And a Notice of Requirement to Selwyn District Council and
Applications to Canterbury Regional Council for resource
consents.

By Central Plains Water Trust

**EVIDENCE OF HUGH MAXWELL BLAKE-MANSON
ON BEHALF OF THE SELWYN DISTRICT COUNCIL**

Figure 1 – Community Water Supply Schemes within the Proposed CPW service area

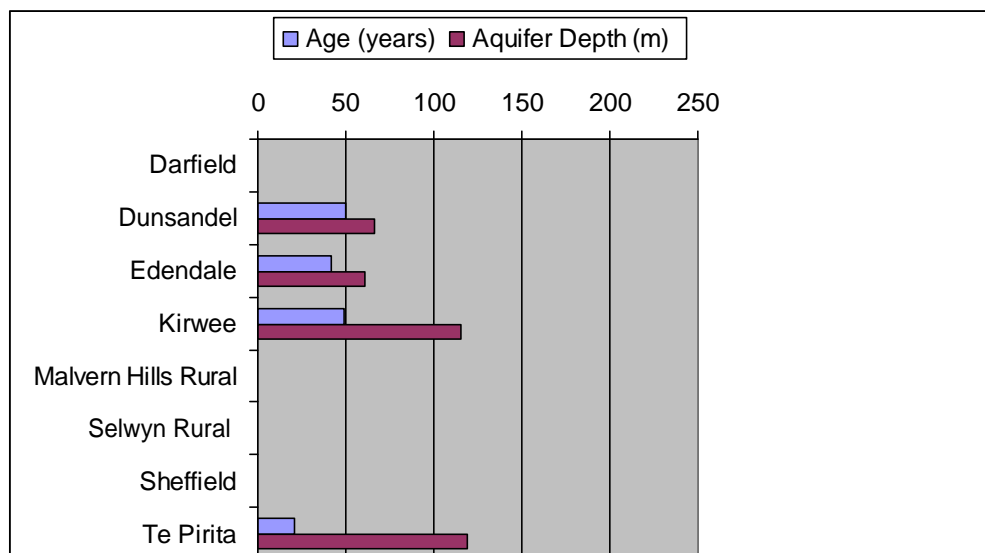
4.10 Figure 1 shows that in Kirwee and Te Pirita, suitable community groundwater is currently available below 100m, and it is between 20-50 years old.

Figure 2– Community Water Supply Schemes down gradient of the proposed CPW service area

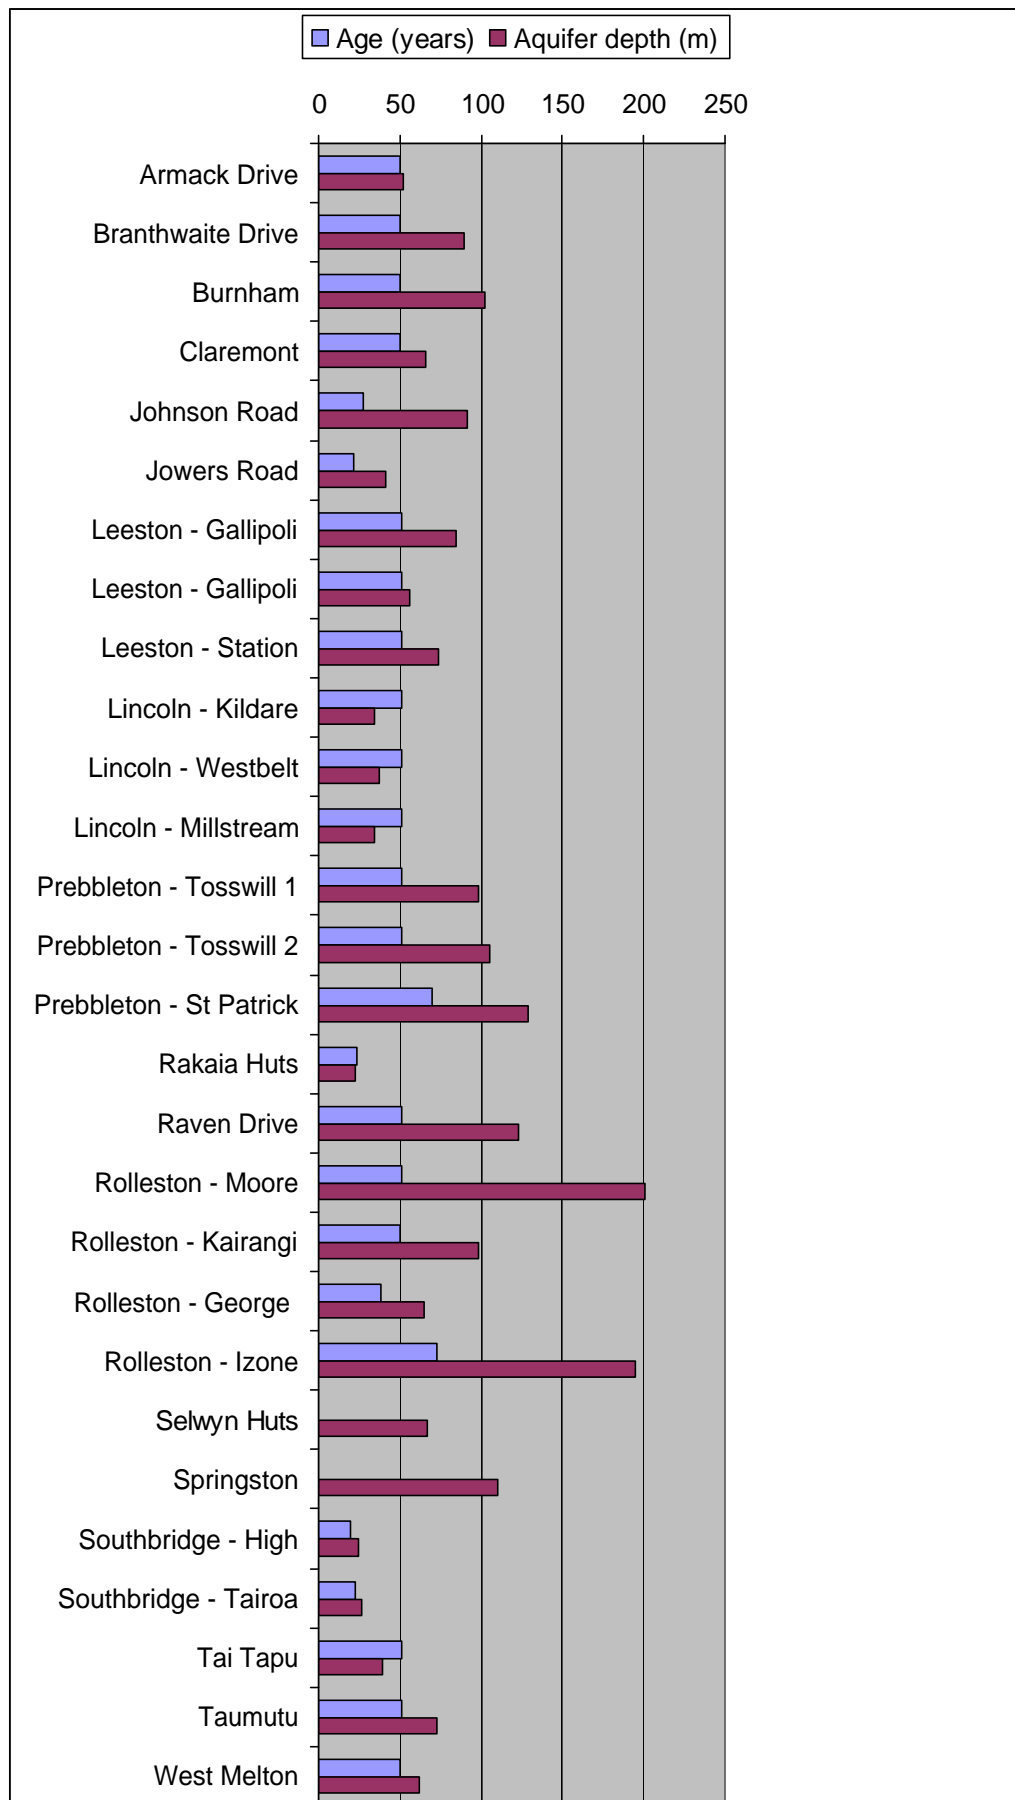
4.30 As identified in Figure 2, a number of wells have water ages within 10-30 years, particularly those near the West Melton special groundwater zone. These are also recognised as unconfined aquifers. While security has been proven in accordance with the DWSNZ. It is important to note that the security definition is only related to microbiological contaminants and does not in my view relate in any way to contamination risks from nitrates. I have already expressed concern at the uncertainties involved in the accuracy of Mr Tipler's modelling and therefore the potential effects on community water quality and the possible change to the secure nature of these wells.

4.31 Mr Callandar notes that in his assessment of the CPW nitrate modelling, and with increasing distance downgradient of the scheme area, the reliability of the mixing modelling becomes “more realistic”. While these locations are towards Te Waihora / Lake Ellesmere, Council has recorded community water scheme water ages of 20 to 50 years.

4.32 If CPW proceeds, their land use impacts would not be observed for at least 20 years in groundwater quality reduction. This reduced quality groundwater water would still be there in a further 20 years. I do not consider it is acceptable to subject future generations with effects resulting from reduced water quality, particularly as a result of a know activity.

Figure 1.2 Page 109 – J. Weir Evidence

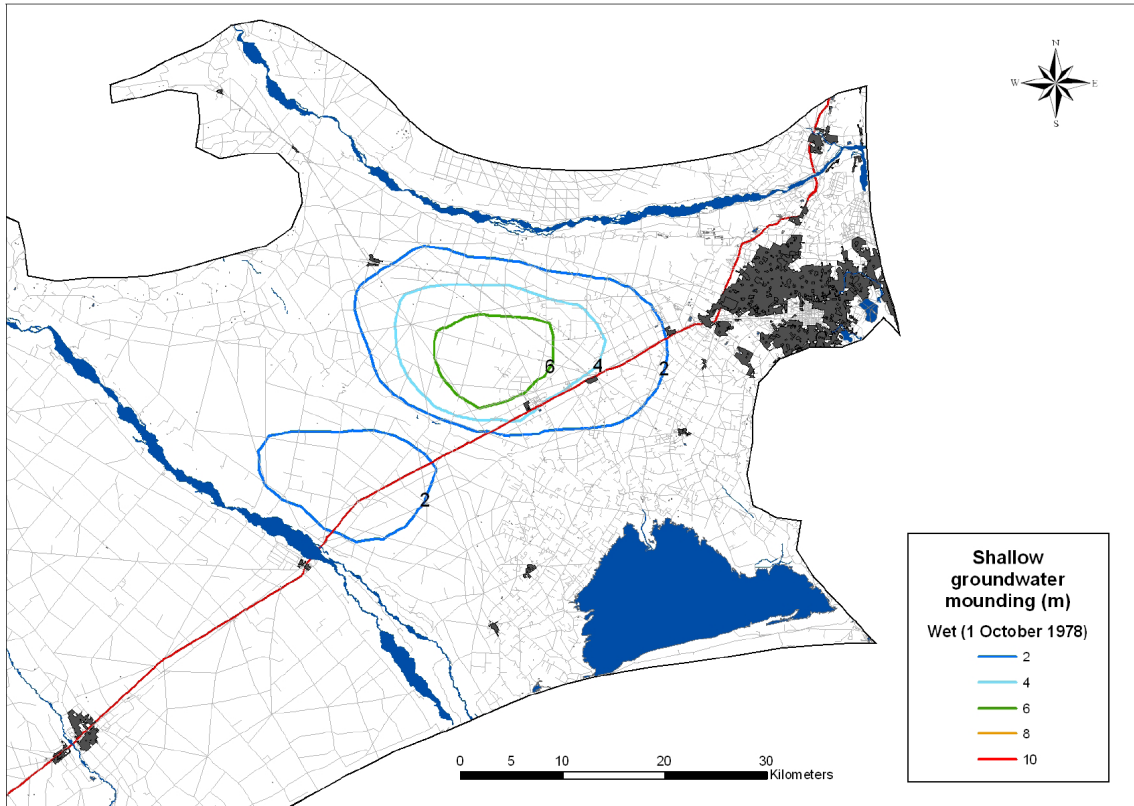
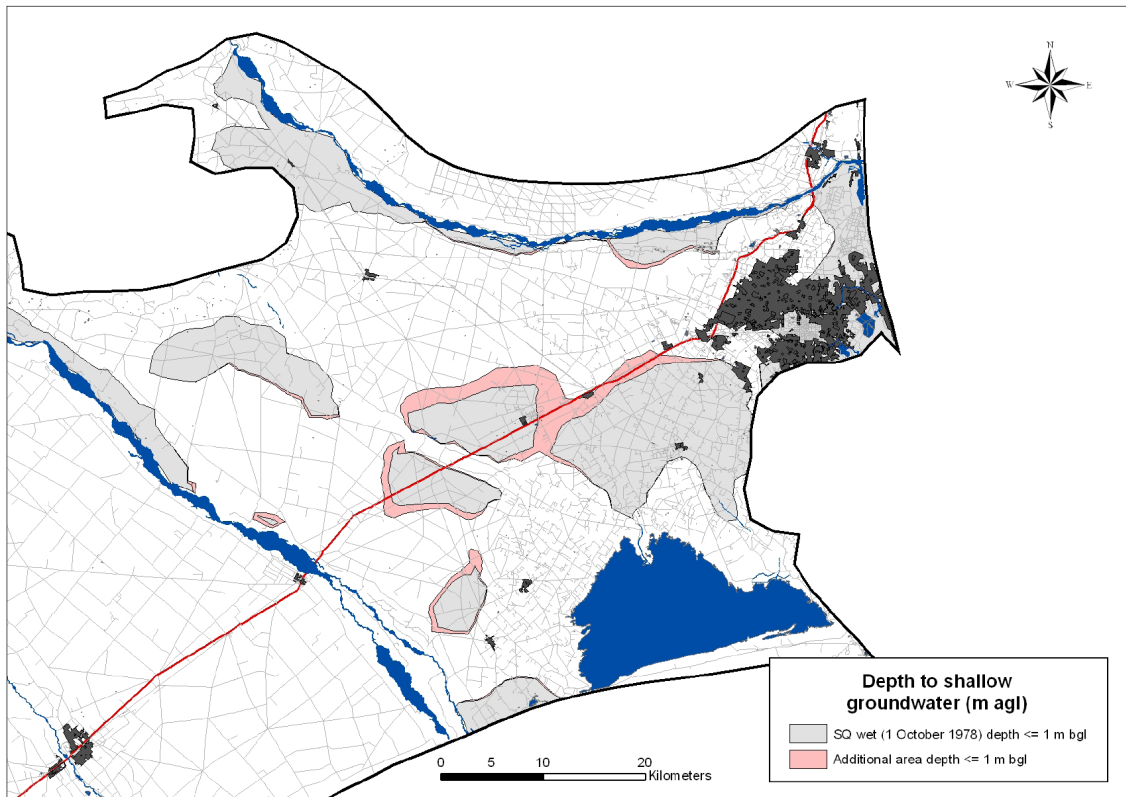
“We used the groundwater model results from Aqualinc to assess the likely extent of CPW effects on the urban wastewater systems. Although the model limitations prohibit site specific predictions it still gives some indications on areas with very shallow GW levels. A GIS overlay of the wastewater systems in the lower plains and the modeled increased area of existing shallow GW levels (1m depth contour) and increased area due to CPW for a wet period (October 1978) –Appendix 1- Figure 1”

In our opinion the groundwater levels, after implementation of CPW, will not be significantly different from their historic patterns and magnitudes in the past, and these will continue to be dominated by climatic variables and natural recharges, which will not be altered significantly by CPW. Therefore SDC’s wastewater needs in relation to groundwater (or other groundwater related infrastructure concerns) will be similar to what has occurred in the recent past and is reasonably well known. But it is also clear that CPW will raise groundwater levels and cause some adverse effects, even if these will be small.

Figure 1 indicates that the area with very shallow GW will expand and will cover the reticulated system in Rolleston due to CPW. However the model results do not show GW within 1m from ground in the area around Leeston. On the other hand this area is known to have very shallow GW and SDC stated that GW inflow into the pipe system was observed in wet periods.

The CPW predictions of groundwater level rise for this wet period are attached to my evidence, Appendix 1 - Figure 1.2 and Figure 1.3

3.9 The URS memo dated 17 March 2008 identifies that the proposed CPW scheme will extend the groundwater contour in the Rolleston area to 1m depth during wet periods and the mean groundwater level will rise by approximately 3.3m. A similar, but slightly smaller rise is predicted in the extreme/higher winter level events. Based on this information, the mean unsaturated zone would reduce from 6.7m to 3.4m, an approximately 50% reduction. The expected faecal coliform reduction within the unsaturated zone would be adversely affected by this reduction in the unsaturated thickness. This would most likely extend the predicted groundwater contamination zone, established in the Pines 1 consent application.

3.10 Based on the information provided, the proposals by CPW would have a detrimental effect on Pines – existing and the planned phase 2 extension to the consented capacity, in that it will
